UNITED STATES PATENT AND TRADEMARK OFFICE

APPLICATION NO.	FILING DATE	FIRST NAMED INVENTOR	ATTORNEY DOCKET NO.	CONFIRMATION NO.
10/678,028	09/29/2003	Sameer P. Pendharker	TI-33654	9934

Office Action Summary

DETAILED ACTION

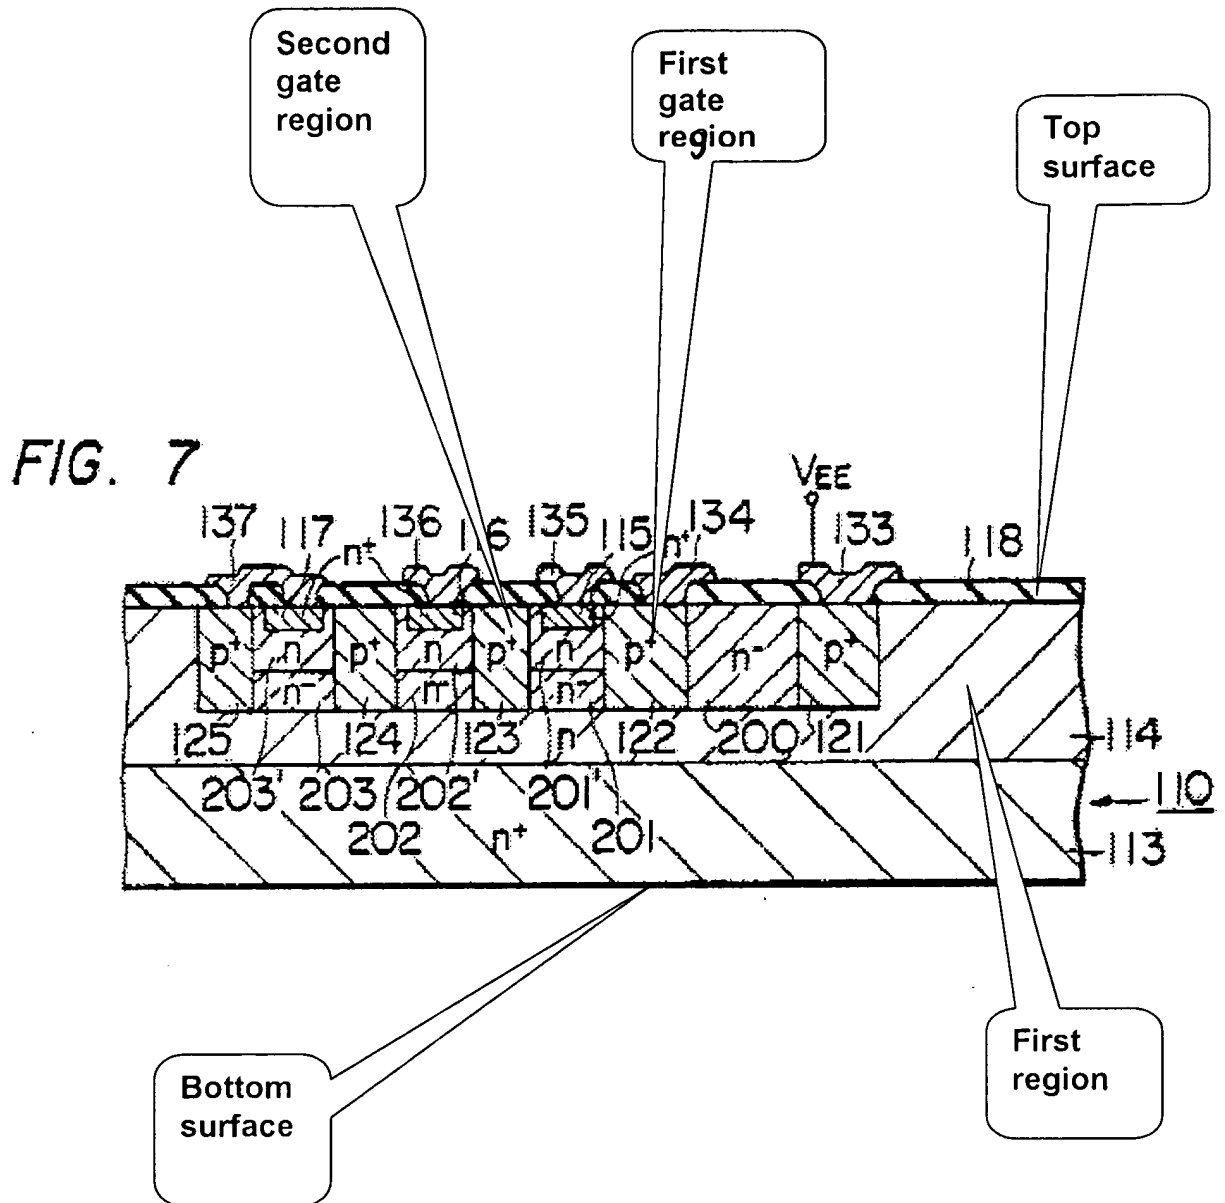
Regarding claim 2, Nishizawa'618 (Fig. 7) discloses an integrated-circuit device, comprising:

a substrate 113 (column 6, lines 20-22), having a top surface and a bottom surface;

a first region 114 near the top surface;

a first and second gate regions (122,123) in the first region 114 (column 7, lines 9-10), each having a top surface, a bottom surface and a side surface;

the side surfaces of the first and second gate regions (122,123) being substantially parallel to each other and substantially perpendicular to the top surface of the substrate 113 (see Fig. 7 Labeled by the examiner below);

the top surface of the first gate region 122 being electrically communicable to a gate terminal 134;

a channel region 201 in the first region 114 (column 9, lines 22-26), between the first and the second gate regions (122,123) having side surfaces adjacent to the side surfaces of the gate regions (122,123), a top surface, and a bottom surface (column 9, lines 32-34); and the top surface of the channel region 201 electrically communicable to a drain terminal 135 of a drain region 115 (column 7, line 10), the bottom surface of the channel region 201 electrically communicable to a source terminal 113 (column 7, lines 13-15).

Nishizawa'618 does not disclose that the drain region 115 can serve as a source region, and the source region 113 can serve as a drain region.

Regarding claim 10, Nishizawa'618 discloses that the first gate region 122 has a pill-box shape with a substantially flat top surface and bottom surface and a side surface substantially perpendicular to the top and bottom surfaces (see Fig. 7 above).
